## Product Change Notice (PCN)

PCN Number: **PCN-0451185R-01**

Product(s) Affected: PJ-050B

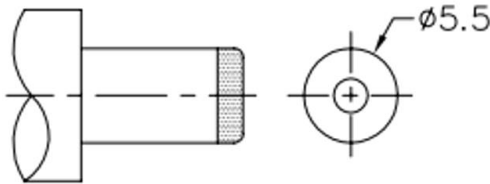
Description of Change: *Mechanical, electrical, and material changes as shown below:*

MATERIAL	PLATING
center pin	copper	nickel
terminal 1	brass	tin
terminal 2	copper alloy	tin
terminal 3	brass	tin
plastic	PBT

DESCRIPTION	MATERIAL	PLATING/COLOR
center pin	copper alloy (H65)	nickel
terminal 1	C2680 t=0.35	nickel-silver
terminal 2	C5210 t=0.25	nickel-silver
terminal 3	C2680 t=0.30	nickel-silver
cover	PA9T UL94V-0	black
housing	PA9T UL94V-0	black

MATING PLUG  
Jack Insertion Depth: 8.5 mm

MATING PLUG  
Jack Insertion Depth: 9.6 mm

Operating temperature range changing to -25C ~ +85C
